**PRELIMINARY/FINAL DRAINAGE REPORT  
FOR  
JOHNSON ESTATES FILING NO. 1**

**CCES RESPONSES**

Job no. 2575.00

PCD Project No. SF-20-xxx

JOHNSON ESTATES FILING NO. 1  
FINAL DRAINAGE REPORT  
PRE-DEVELOPED DRAINAGE MAP

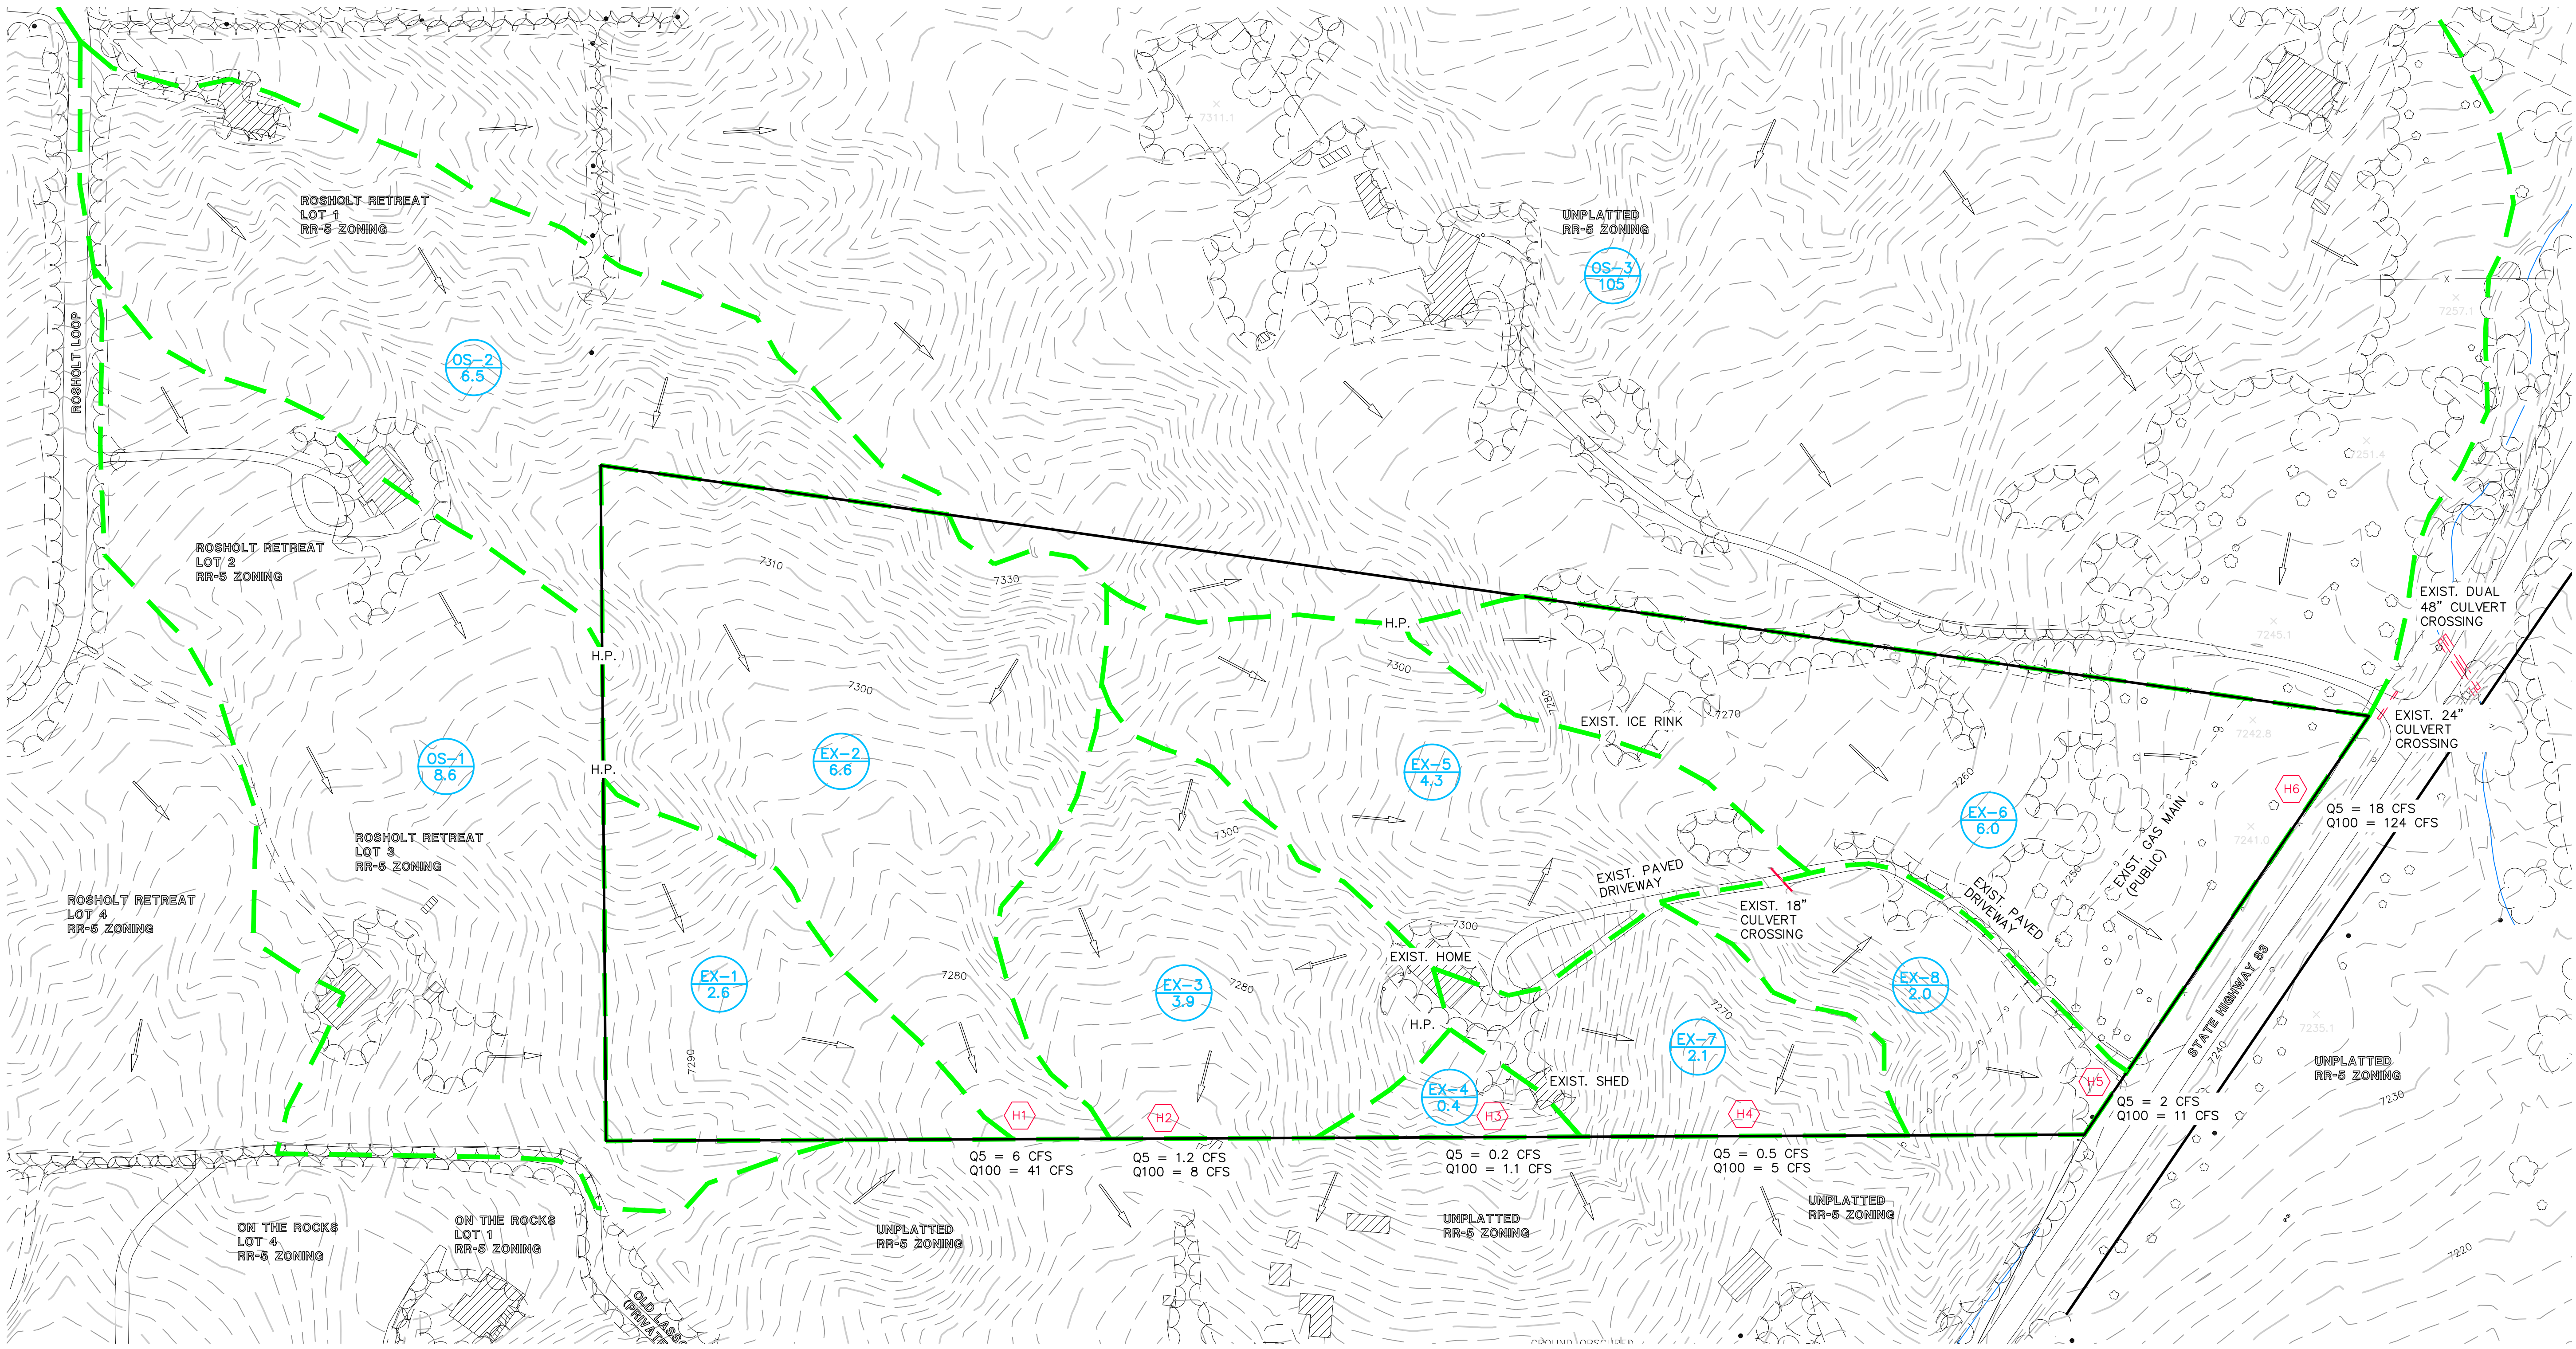
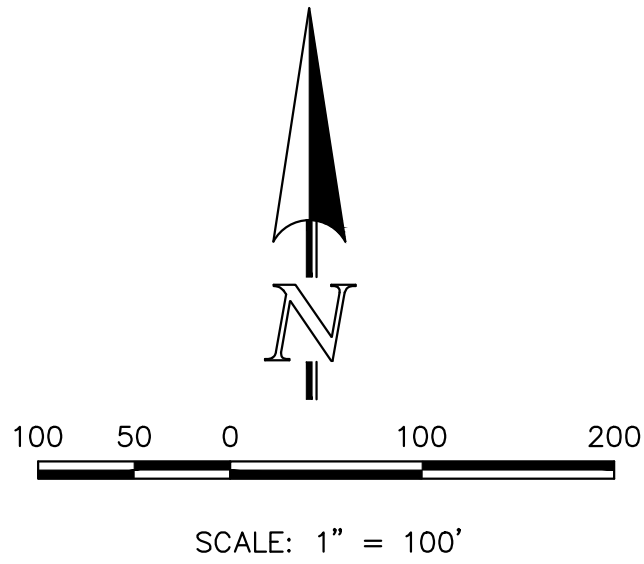
Elaborate on the historic pattern. The drainage map appears to show this overtopping highway 83. To what extents and depth?

**ADDED ADDITIONAL DESC. TO NARRATIVE RE: EXIST. CONDITION.**

JOHNSON ESTATES FILING NO. 1  
FINAL DRAINAGE REPORT  
DEVELOPED DRAINAGE MAP

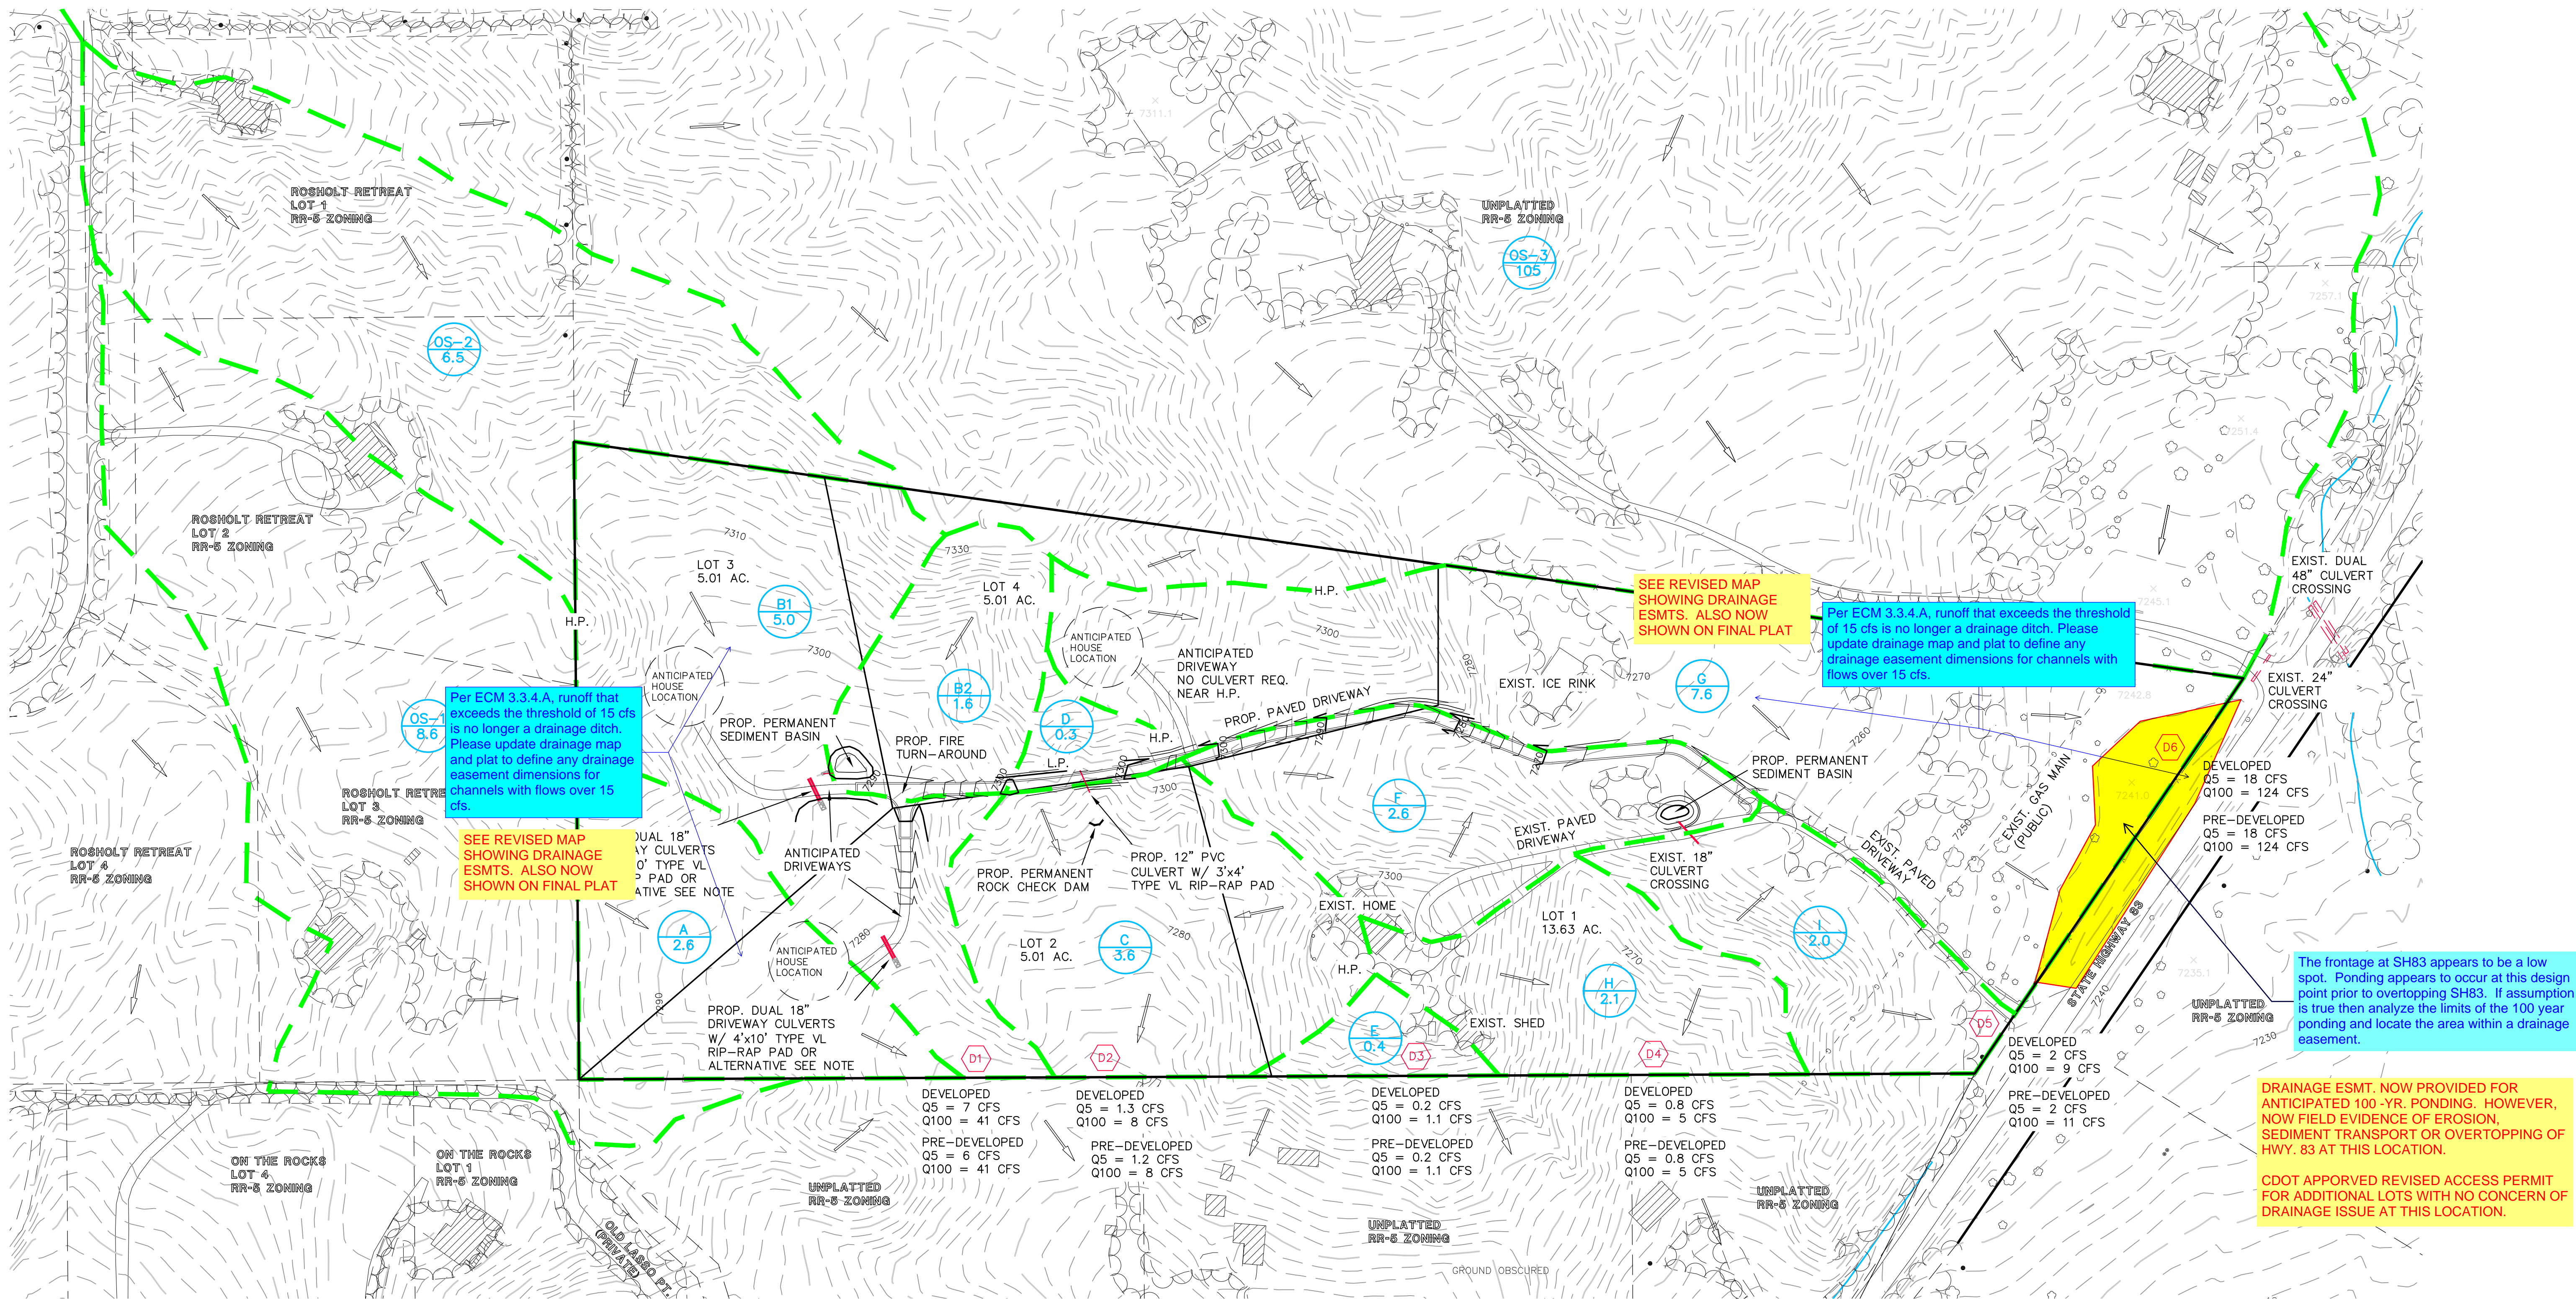
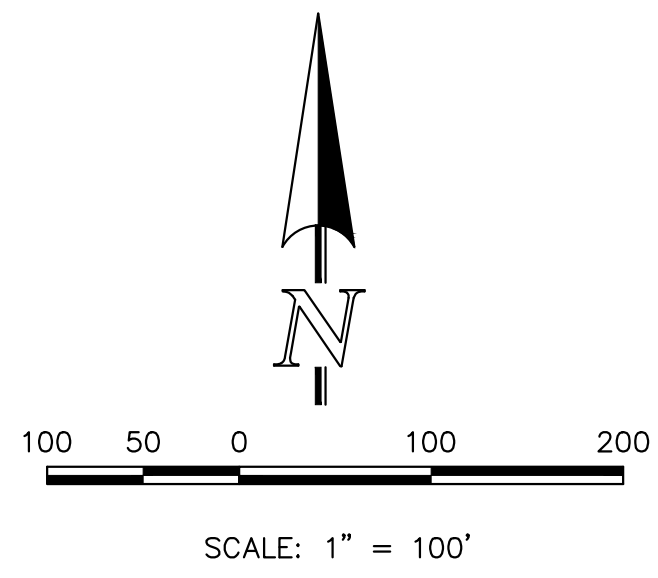
Please update drainage map to show all proposed drainage easements for drainage ways and sediment basins.

Please provide detail for dissipators in construction drawings.

ESMTS. NOW SHOWN ON MAP AND FINAL PLAT.

SEE REVISED.  
DETAILS NOW PROVIDED
